VHB
 Job Number: 57438
 Reviewed By: KZS
 Date: 3/18/2014

BRIDGE RAIL DETAILS SHEET

TOWN OF MIDDLEBURY, ADDISON COUNTY, VT RTE 125 (MAJOR COLLECTOR), BRIDGE NO. 13		EM13-252 MIDDLEBURY RS 0174 (B)	
R.NO.	DATE	BY	NO.
E		E	
V		V	
DRAWN		E.P.	
CHECKED		D.L.	
APPROVED		3/10/14	
SCALE		SCHEMATIC	
DRAWING NO. FRL - MIDDLEBURY

Calvanized 2-Rail Bar Beam Guardrail Approach Section

BILL OF MATERIALS, WV 4

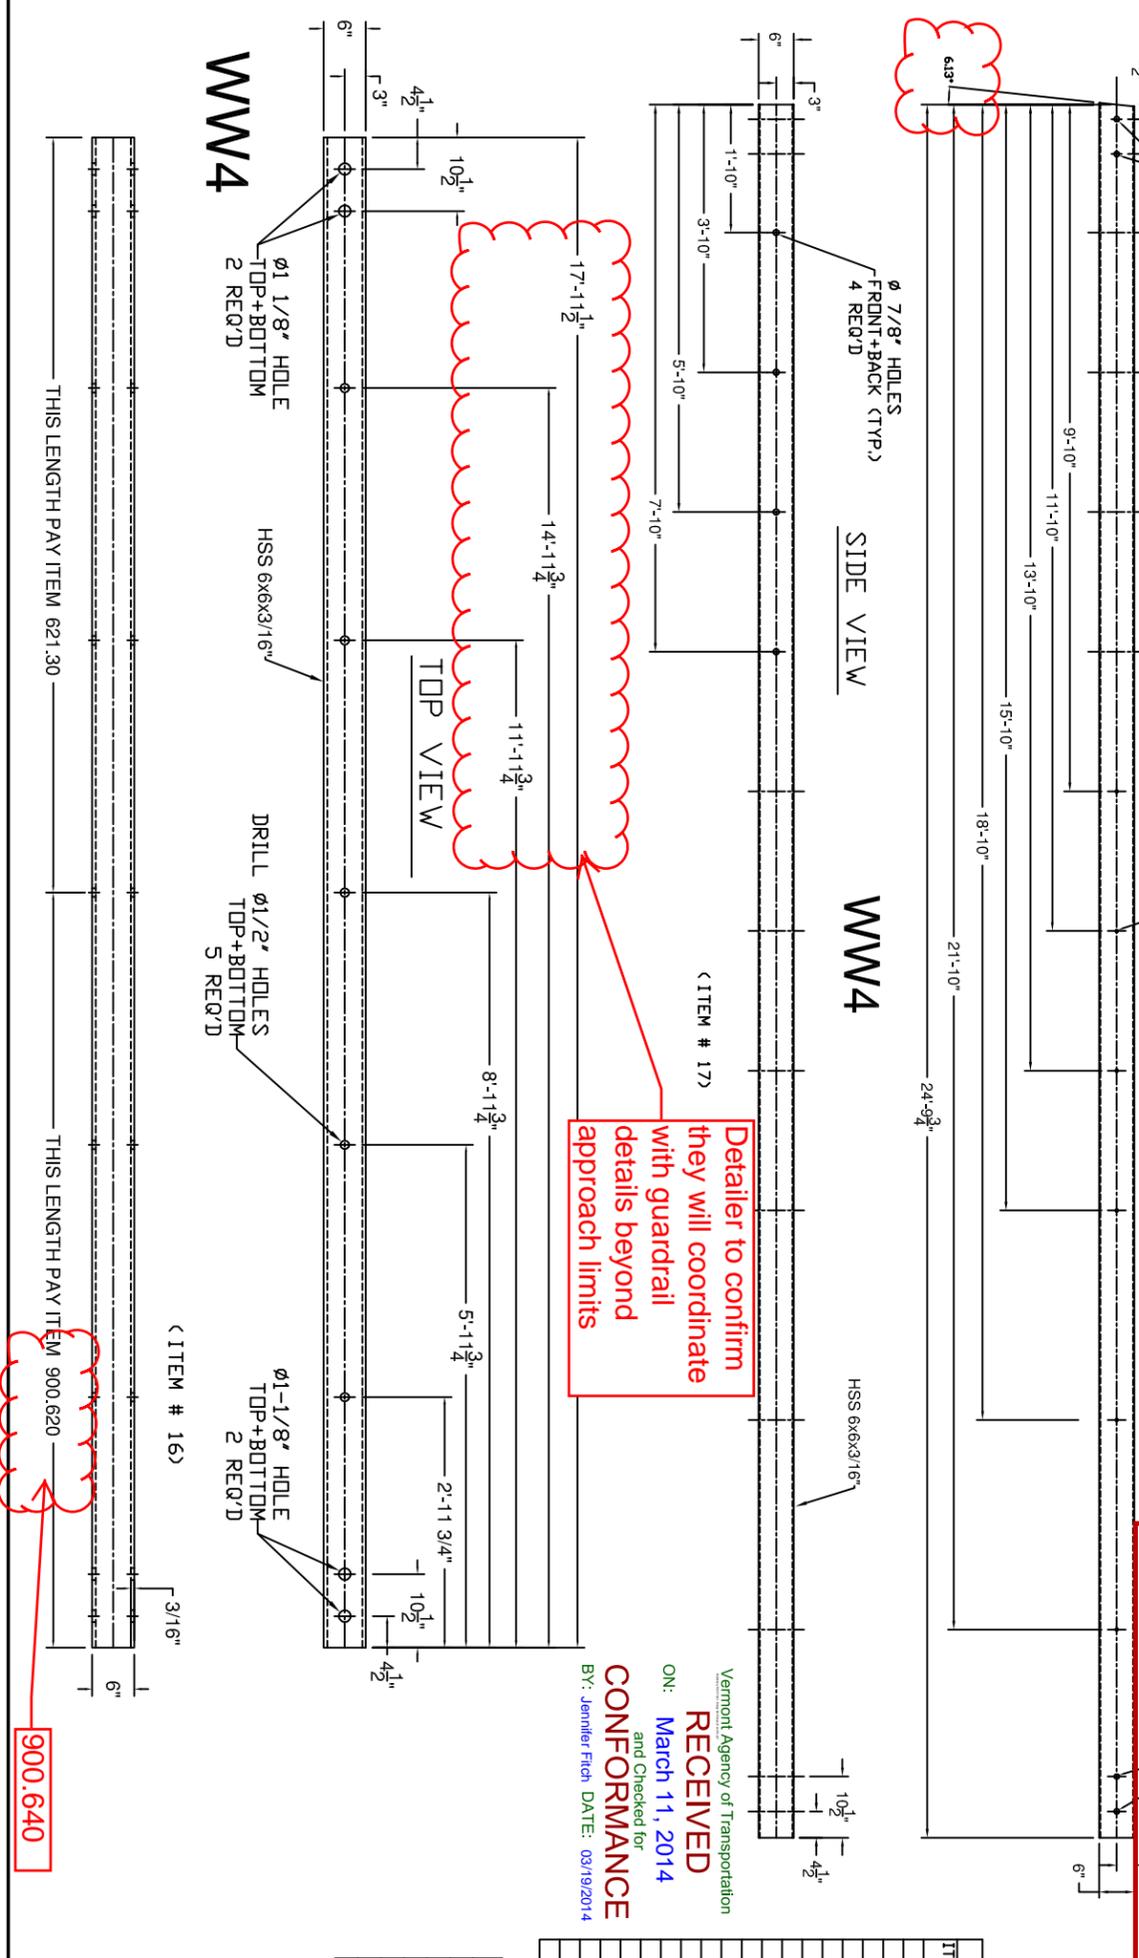
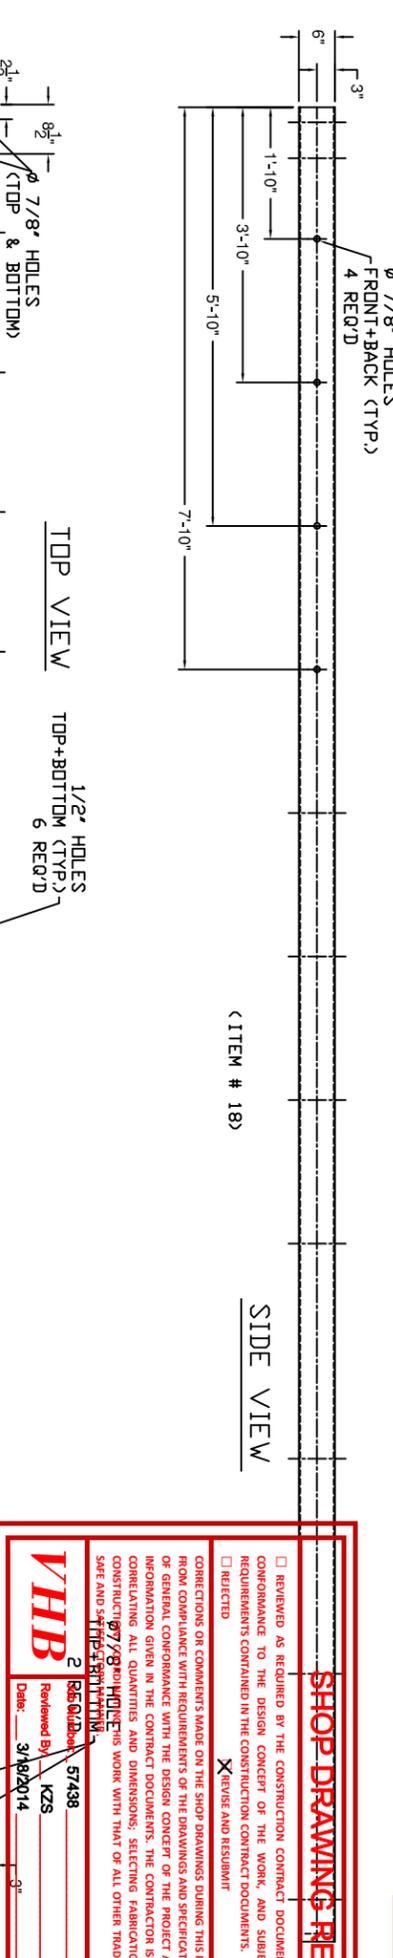
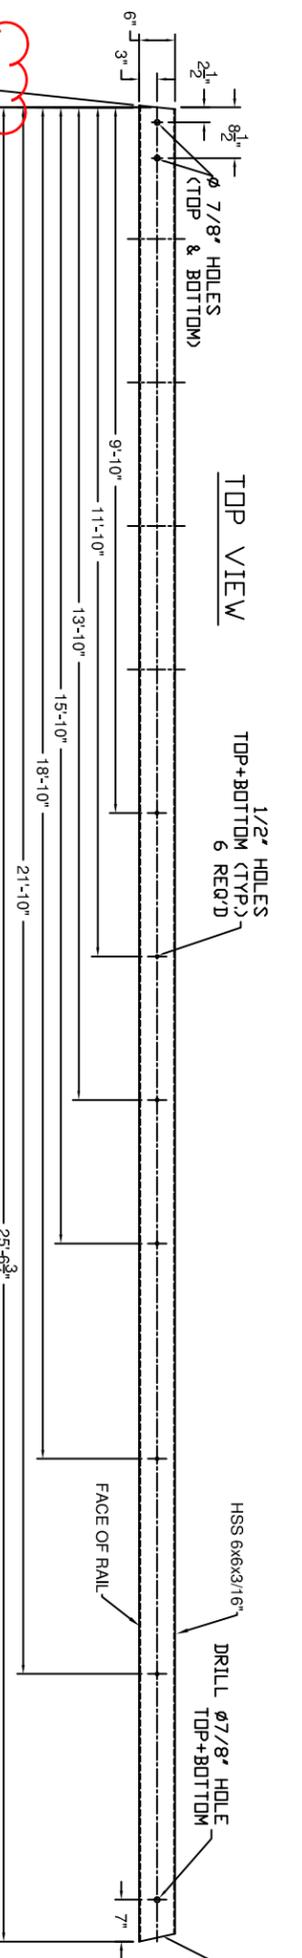
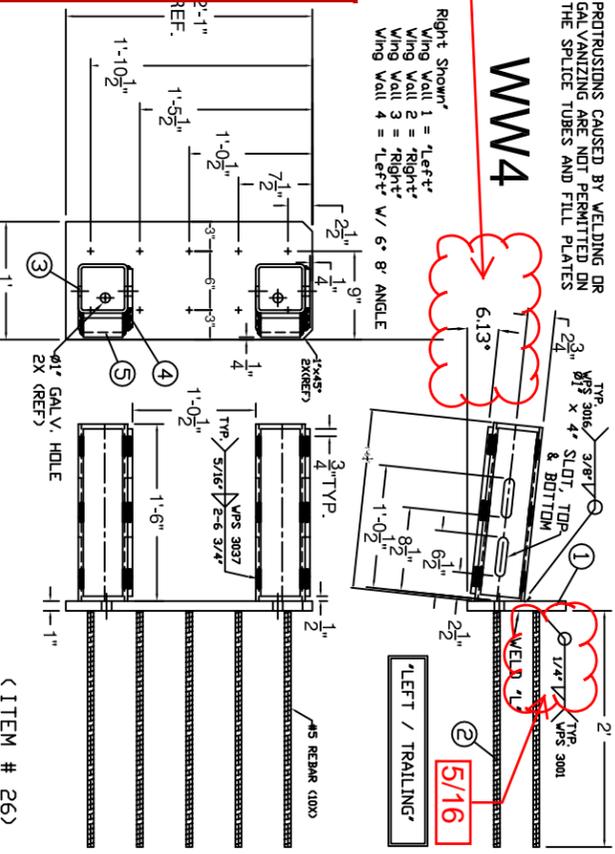
Detailer to confirm they will coordinate with guardrail approach limits

confirm angle (typ.)

confirm member size
